SERVICE BULLETIN 008: XT-912/582 REAR HUB AXLE INSPECTION

Identification	SB-008
Status	Mandatory
Issue	2
Issue Date	October 2011
Applicability	All XT Aircraft
Compliance	At or before 100 hours of operation.

Summary of Changes: Clarify the applicability of this service bulletin, and introduce type 4 axle for issue 2.
--

Figure 1 Photograph showing crack

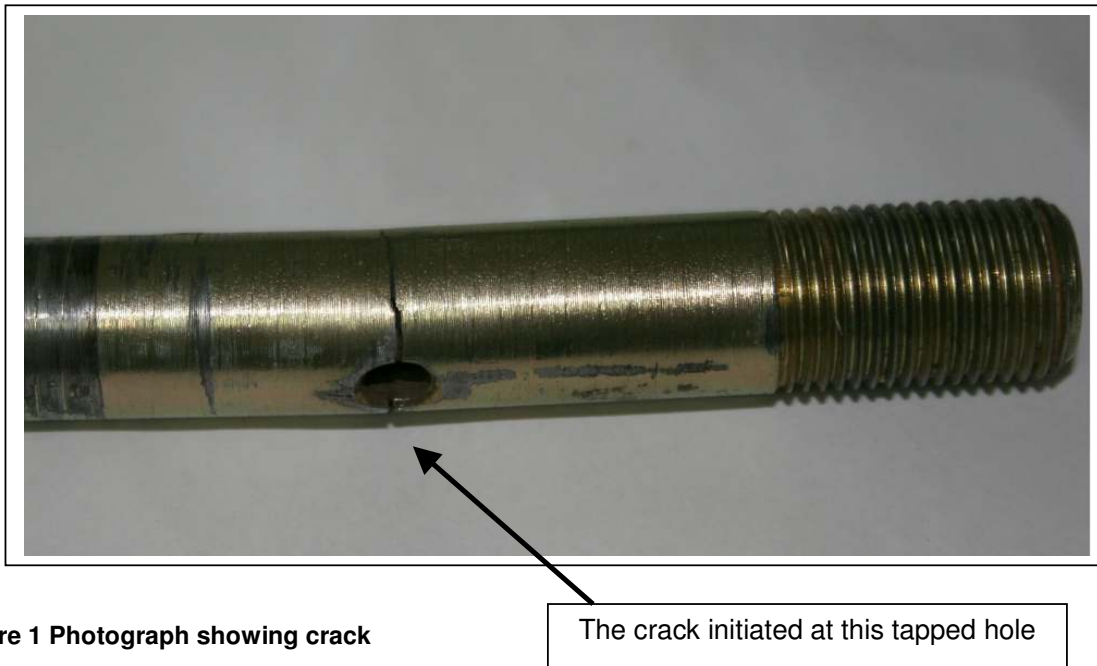
It has been brought to the attention of Airborne that a rear axle - Airborne part # 108452 - HUB AXLE EDGE XT TYPE 2, has been found to be significantly cracked at the tapped locking bolthole. The aircraft involved was a XT 912 tourer edition with approximately 250 service hours.

The crack initiated at this tapped hole

- Remove, clean and inspect the axles after each 100 hours, and during tyre changing.
- A 10 x magnifying glass should be used to aid this inspection.
- Any cracks however small are reason for replacement of the component.
- Repeat this process each 100 hours, as well as each time tyres are replaced.
- Any cracked components should be reported to Airborne Windsports to aid service history.
- Conduct an inspection according to the checklist (Chapter 20 – Standard Practices Airframe).
- Complete a service note in the aircraft logbook.
- It is suggested that if a crack is found in one axle then both should be replaced at the same time.

Figure 2 Type 1 axle image (From 5422). To be replaced by 104938 - HUB AXLE EDGE XT TYPE 1

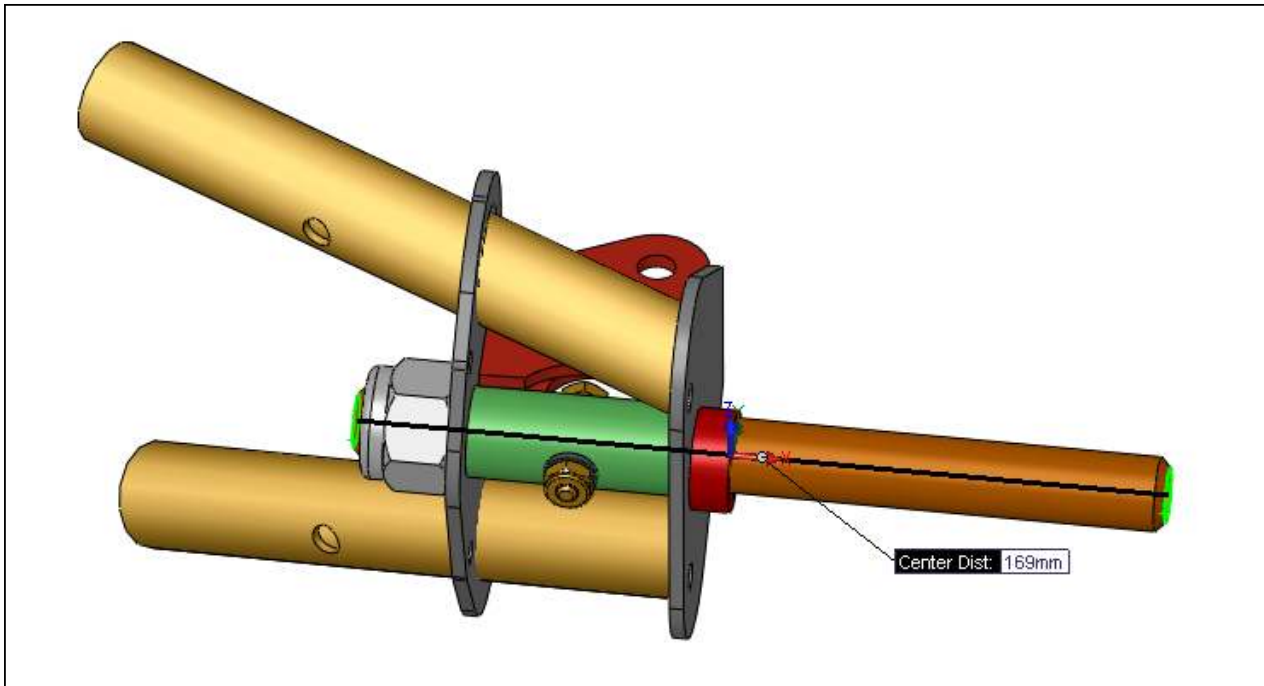
Type 1 is a **hollow** axle prevented from rotating by a bolt through the axle. The axle is 169mm long.

Figure 3 Type 2 axle image (From 7392). To be replaced by the type 4 axle using the retrofit kit 110030 - HUB AXLE EDGE XT TYPE 4 RETRO KIT

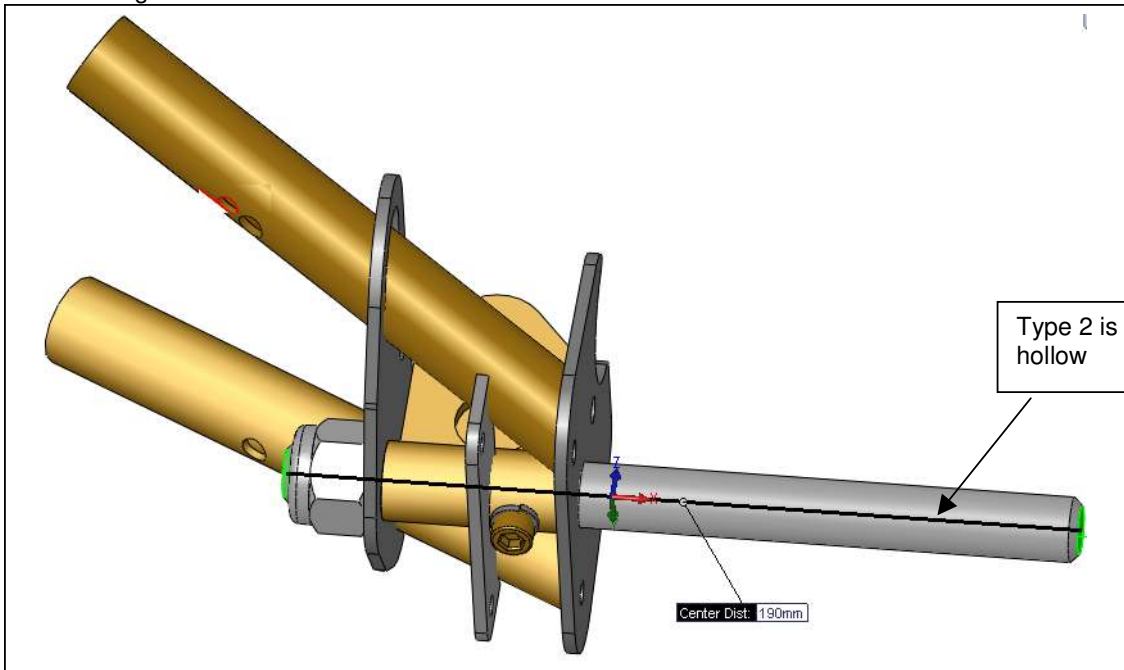
Type 2 axle is a **hollow** axle prevented from rotating by a tapped hole and blind bolt into the axle. The axle is 190mm long.

Figure 4 Type 3 axle image (From 7392). To be replaced by the type 4 axle using the retrofit kit 110030 - HUB AXLE EDGE XT TYPE 4 RETRO KIT

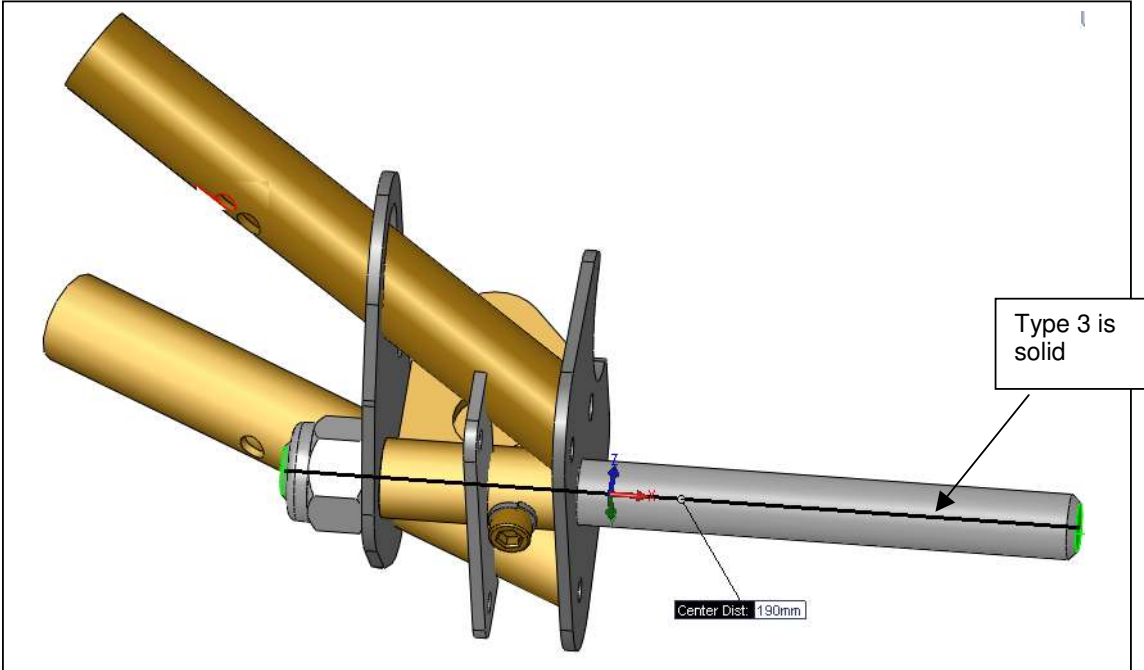
Type 3 axle is a **solid** axle prevented from rotating by a tapped hole and blind bolt into the axle. The axle is 190mm long.

Figure 5 Type 4 axle image

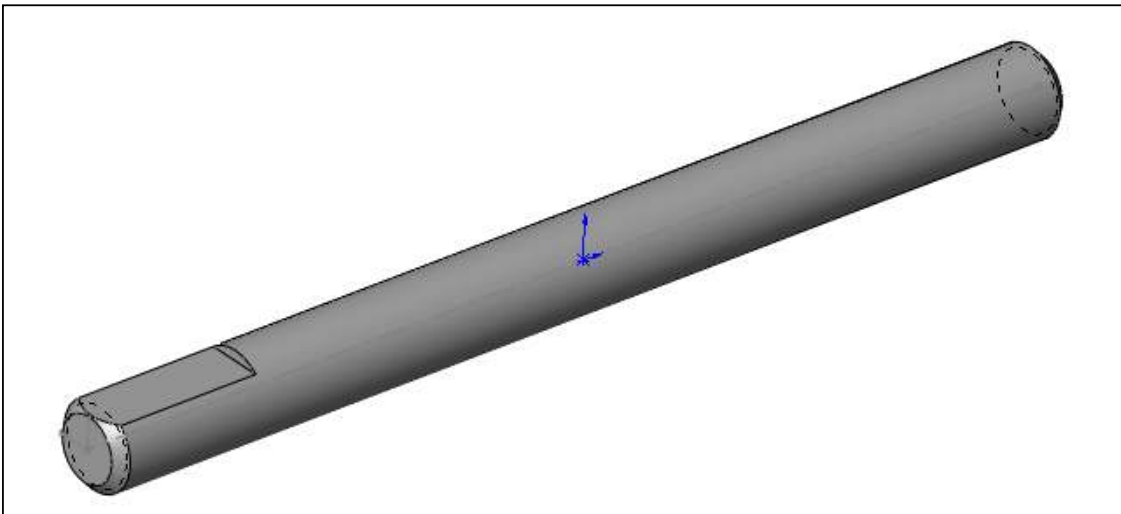
A further improvement has been made to completely remove the drilled hole from the axle with the introduction of the type 4 axle in January 2010.

Type 4 axle is a solid axle prevented from rotating by a milled face which keys into a plate. The axle is 190mm long.

Figure 7 Latest type 3 HUB integrates the flat face into the hub, and does not require the retrofit kit.

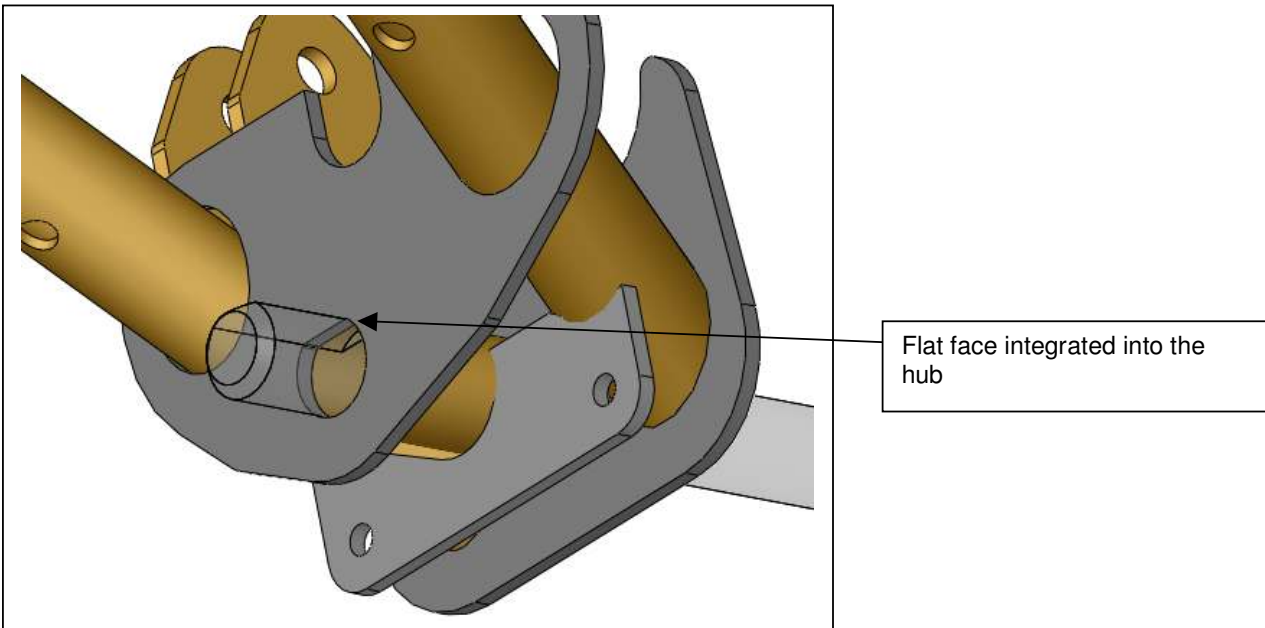
The newest hub design integrates the flat faced hole into the hub. And therefore does not require the retrofit kit, only the Type 4 axle itself.
